From: Sent: To: Cc: Subject: Attachments: Frank Cassidy Thursday, September 26, 2024 2:11 PM Carter Nevill Department Heads Fw: Flooding on Oliver city road image001.jpg

Our Stormwater Administrator inspected the area and found there were clogged storm pipes downstream of the development causing a backup. This didn't allow the water to release quick enough to provide relief for what was occurring upstream. This makes sense since Mr. Teigen's property is not located within the mapped FEMA floodplain. The contractor is currently flushing the downstream pipe to remove the debris and sediment that accumulated in those pipes. This is a private matter between the developer and Mr. Teigen. Please let me know if you have additional questions.

# SITE DEVELOPMENT PLAN WARRENTON CROSSING TOWN OF WARRENTON, VIRGINIA (REVISION)

#### PROCEDURE FOR CONVERTING SEDIMENT BASINS:

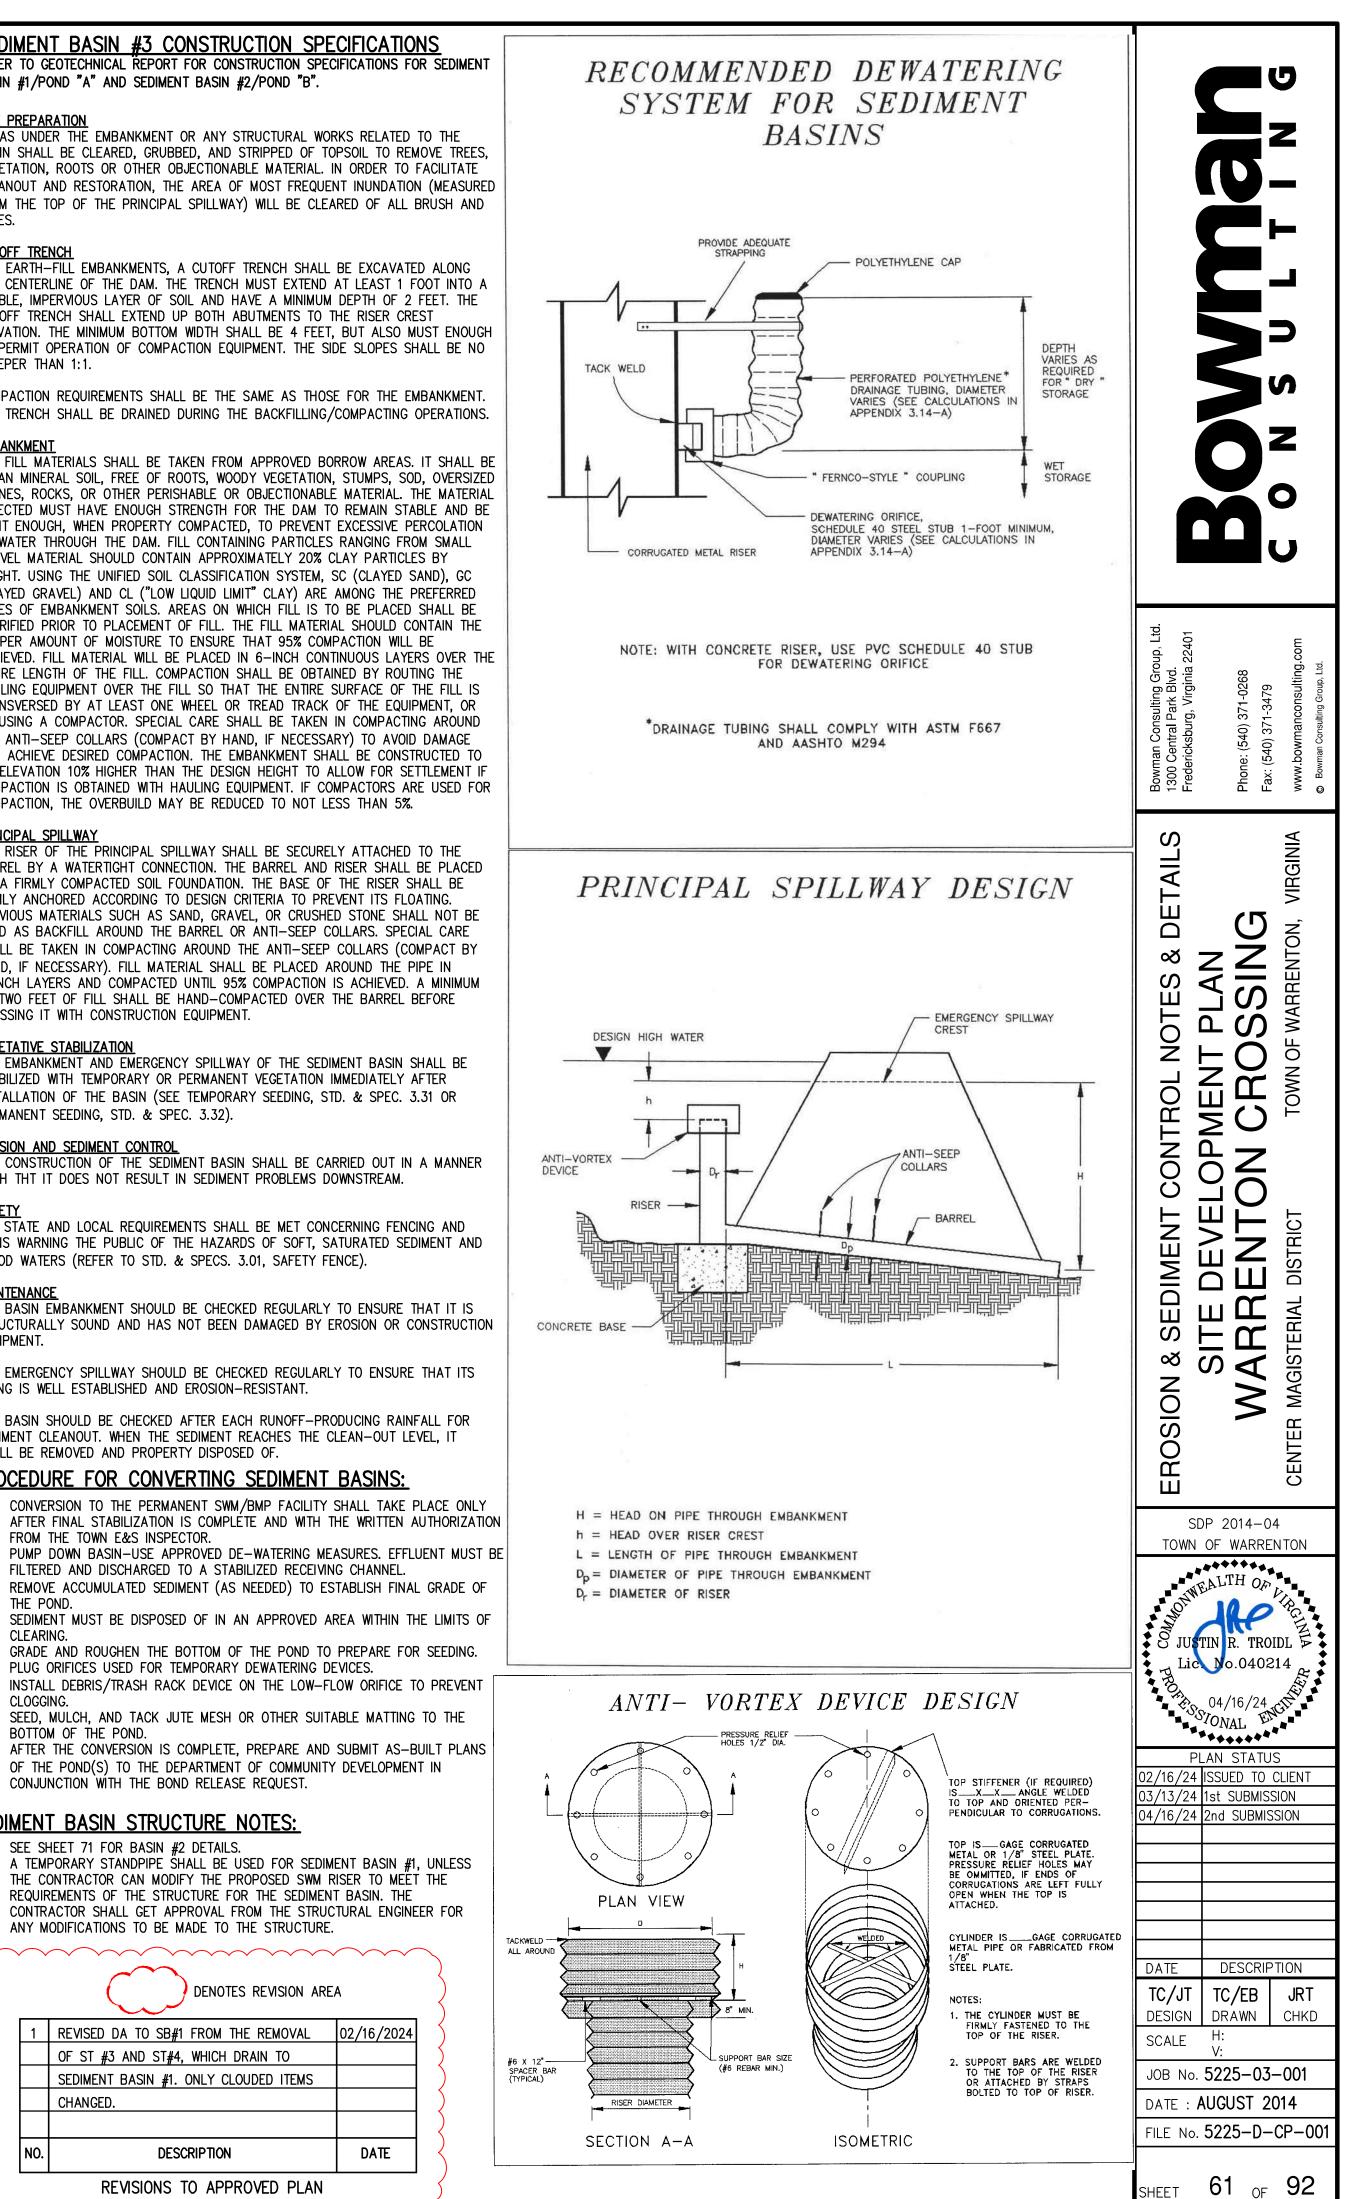
Observation: 1. Sediment basin 2 is currently installed as a sediment trapping practice and is not designed according to the approved plans. No sequencing regarding sediment basin 2 conversion was documented in the approved plans. The decision was made in the field to allow for a sediment trap to be installed in the interim instead of a sediment basin. A sediment trap is designed to take less than 3 acres of drainage area while a sediment basin is for 3 acres or more of drainage. The sediment trap was utilized since the interim drainage area was 2.69 acres. The sediment basin will be installed prior to the storm sewer installation which will increase the drainage area to 29.96 in its ultimate condition. The sediment trap was oversized for the current drainage area. Staff can add or delete erosion and sediment controls as necessary in the field if site conditions change which was warranted since a retaining wall must be built behind sediment basin #2. As an option, a sediment trap was utilized. The plan is going to be updated to reflect the sediment trap that has been constructed in the field. Typically plans are "redlined" with changes that are temporary in the field for documentation purposes, but the plans will be updated to include this temporary change.

1. Provide documentation that sediment basin 2 will be installed per the approved plans. The approved plans referenced a "temporary 8" orifice" (to be replaced at conversion), which is intended to be the dewatering orifice. DEQ requested an updated detail showing the dewatering orifice being retrofitted on the permanent weir structure for further clarification. Our office received a revised detail yesterday, but it was not accepted. I have specified that the engineer provide an actual detail showing the dewatering orifice for the retrofit for sediment basin #2 as intended of the original design.

2. Provide documentation demonstrating that Sediment Basin 3 is constructed to handle a 25-year storm event. A copy of the riser inflow curve graphic was provided. Calculations were provided sheets in the original plan, but this graphic is used to estimate the size of the riser for a 25-year event.
